From: Griffin, Tim
Sent: 18 October 2022 16:46
To: Sharpe, Summer
Cc: Oliveira, Marta; Ellison, Mark
Subject: F/22/93835 MOORLANDS FARM, BOTLEY ROAD, WEST END - Landscape Comments

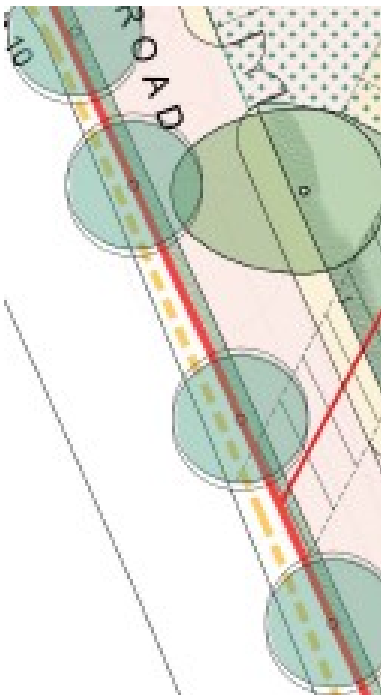
a/ My primary concern is the proposed removal of the double line of established conifers. Usually, the removal of non-native species in this semi-rural location would be favoured, however, in this case it will open up significant views into the site from a number of local Public Rights of Way (PROW's).

Here is a stitched view I took during my site visit which shows the effectiveness of these trees in blocking year-round views into the site:

The removal of these evergreen trees will be a significant change in the scene that will be readily noticed by the casual observer (see my LVIA comments below for further detail).

To balance this loss of screening, we would expect to see a robust and deliverable scheme of native tree and hedge planting along this boundary. Unfortunately, at the moment there is insufficient room within the red line for such planting.

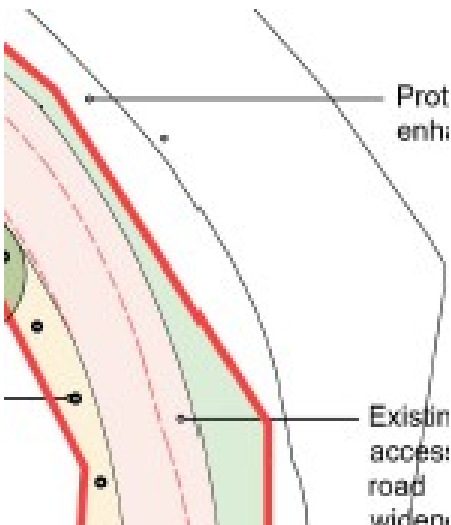
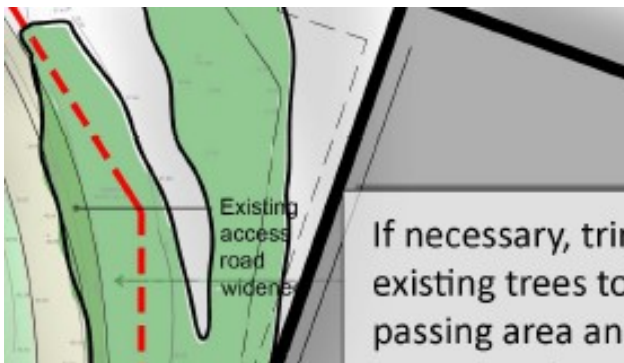
Here is a typical extract to illustrate the issue:

I estimate that the planting strip for the proposed trees shown along the LHS of the drive is under 0.5m wide. This is far too narrow for successful tree or hedgerow planting.

Please can you ask the applicants design team to re-visit this issue and come back with further detailed proposals to demonstrate how the screen planting could be delivered. A planting strip at least 1m wide is

needed to allow successful tree and hedge planting (assuming a pinned/pegged kerb detail to avoid concrete haunching. If standard pcc kerbs are proposed, then the strip needs to be 1.5m wide).

b/ The notes on these plans are misleading:

The road is being widened here and this will definitely lead to loss of part of G1 Hawthorn that presently provides some important screening to Wellington Park. Please amend these notes and add further detail to ensure that any vegetation loss is kept to a minimum. We wish to avoid any possibility of unnecessary/excessive removal of existing vegetation.

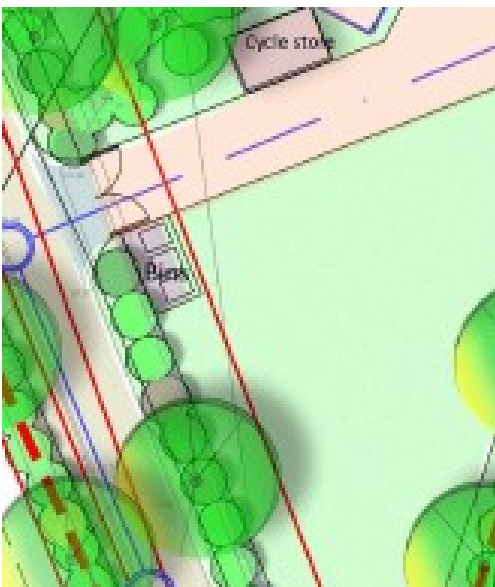
c/ We need clarification of what fencing is proposed to the site boundaries down the length of the access road. In particular, much of the existing boundary fencing along the side of the Public footpath is in disrepair, intrusive and needs to be replaced. Here is a typical example of the view from the PROW:

Please ask for further detail (note - any metal mesh security fencing should be dark grey or black).

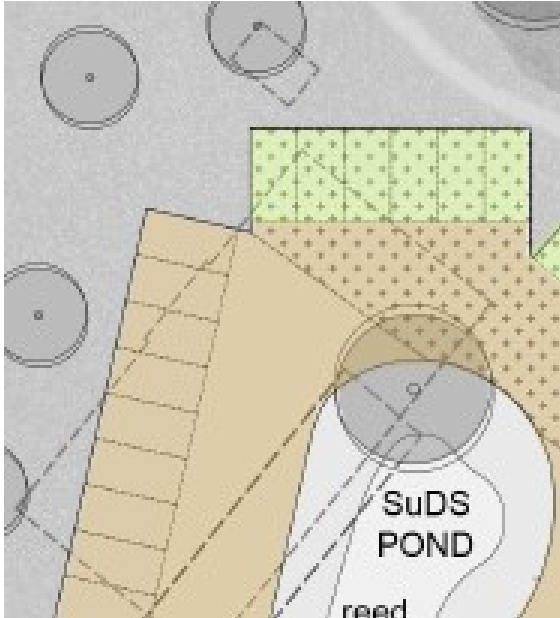
c/ The use of reinforced grass for selected parking bays and yards is generally welcomed, but I wonder how realistic it is to use grass on parking bays in daily use as the grass will quick deteriorate with lack of light. Perhaps some heavily used bays should be reinforced buff gravel instead.

The edge of reinforced grass adjacent the SUDs pond appears arbitrary. I suggest a re-design here with green areas being reinforced grass (bays kept as grass here as assumed these will less well used) and buff being reinforced gravel:

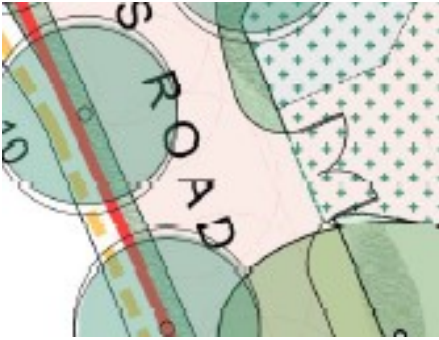
d/ What does the light-yellow strip on the RHS of the access road represent on the extract below:

I presume this is not a footpath as on the landscape plan the strip is shown planted.

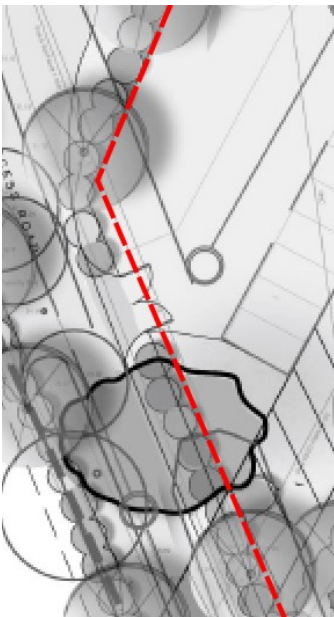
f/ Why are these bins and cycle stores not orientated parallel to the building (as per Unit A).

Is a link path required into the open storage area?

g/ Please pull back the gates and fence line from the road edge by a further 1m (approx. as per dashed red line below) to create a wider strip for planting:

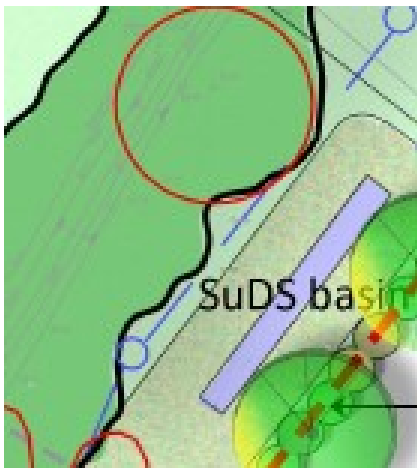
k/ Subject to separate comments from the Ecology Officer, the layout and design objectives within the Ecology buffer zone shown on the landscape plan are generally acceptable. I suggest that a shallow scrape could be included in this area to further boost habitat enrichment. Further design work will be required in due course and all details should be conditioned.

I am not sure if the 'low key path' will be welcomed by the Ecologists who may prefer to see the area undisturbed. Perhaps the area will need to be fenced off to prevent accidental access by pets etc?

Please check as there is an existing shallow ditch in this area, and this should be retained if possible and linked with the SUD's scheme.
